NEI 99-06 [Draft Rev. A]

Standard Improved Technical Specifications and Application of Selection Criteria for Fuel Storage Casks

Revision A
September 28, 1999

Figure 3.2.1-1
OVERPACK Surface Dose Rate Measurement Locations

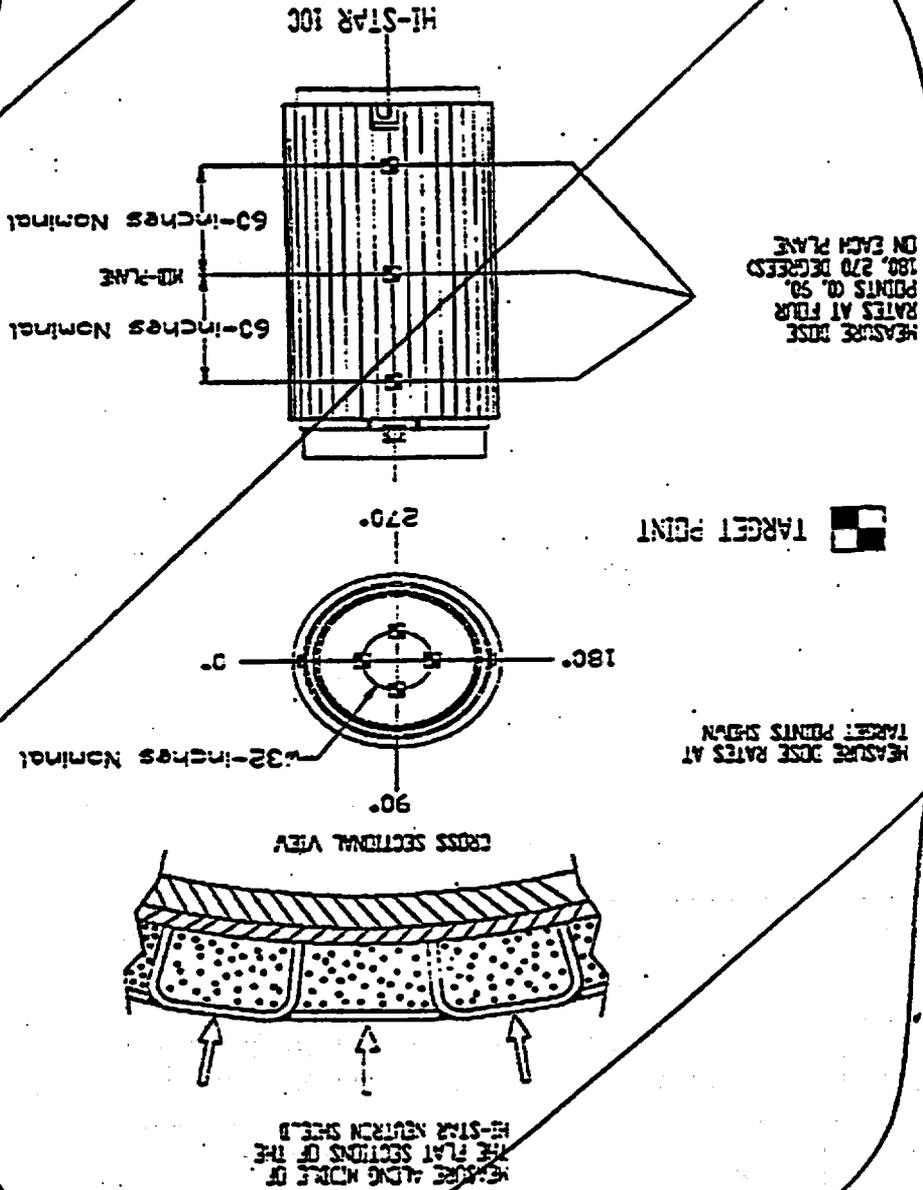
(L.8)

Figure 2.1.1-1
Burnable Poison Rod Assemblies (BPRAs)
Minimum Acceptable Cooling Time as a Function of Burnup

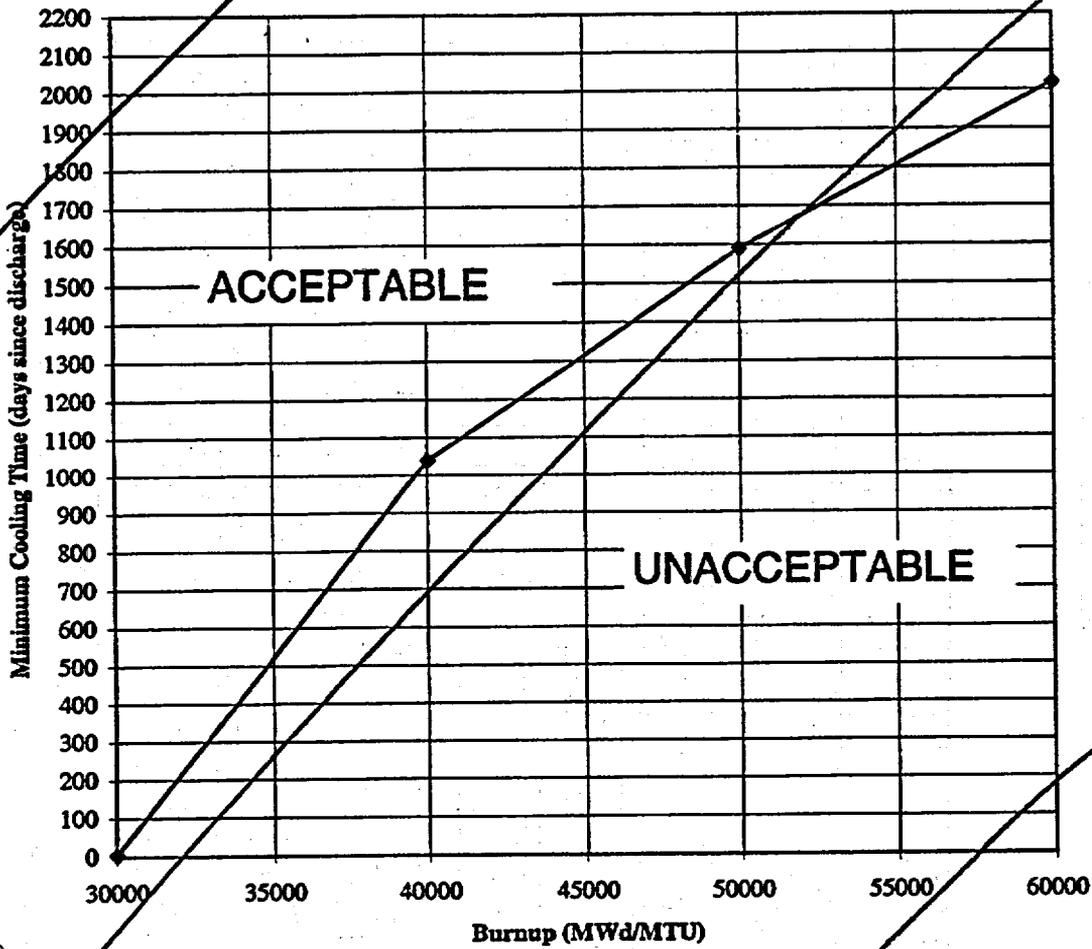
(L.1)

Figure 2.1.1-2
Thimble Plug Assemblies (TPAs)
Minimum Acceptable Cooling Time as a Function of Burnup

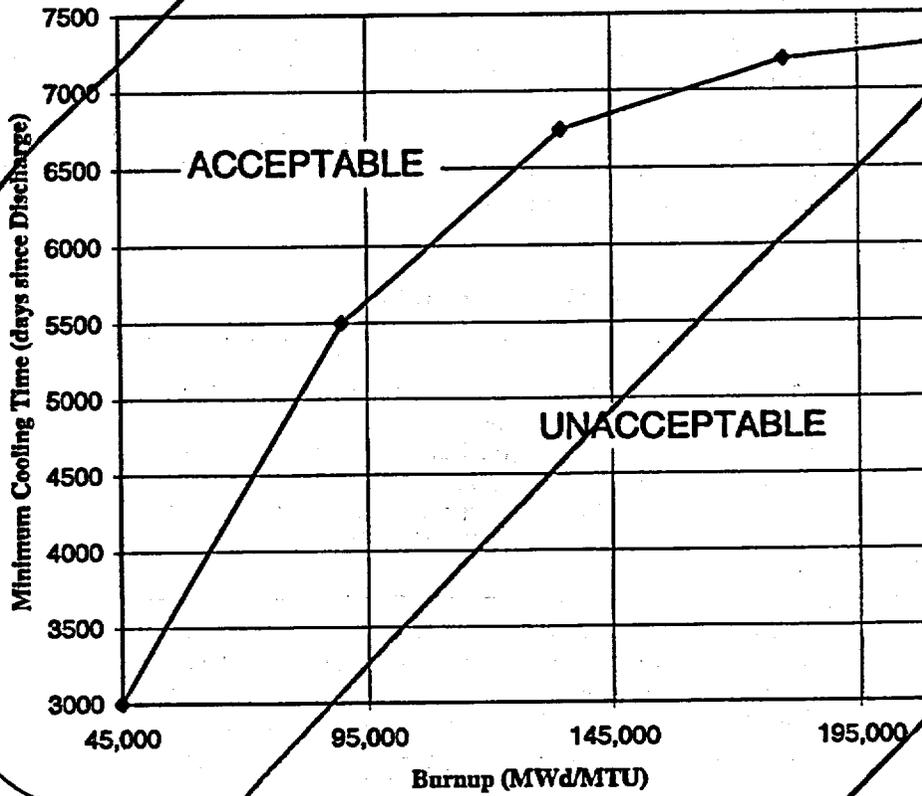
(L.1)

Figure 3-1
CONCRETE CASK Surface Dose Rate Measurement

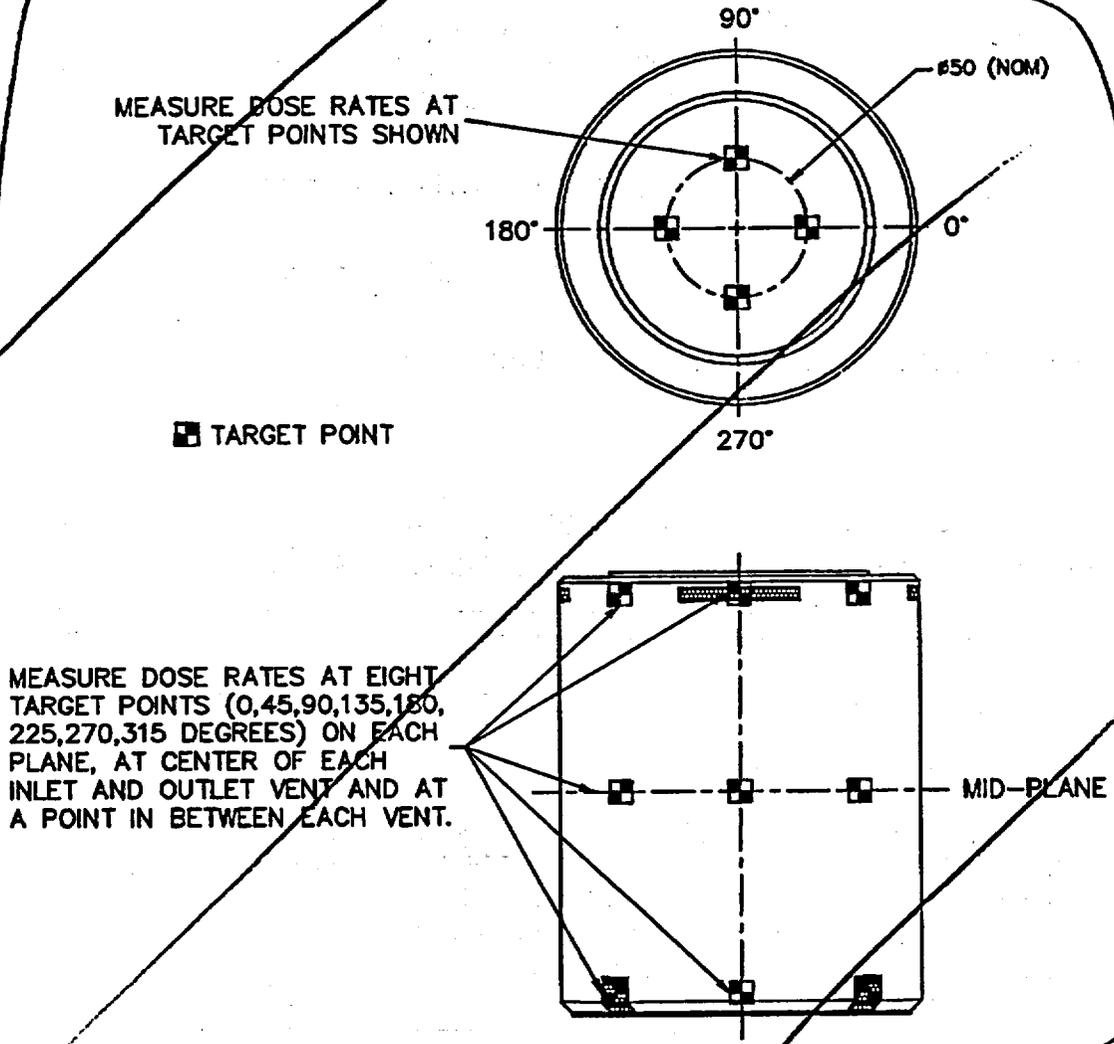
L.8
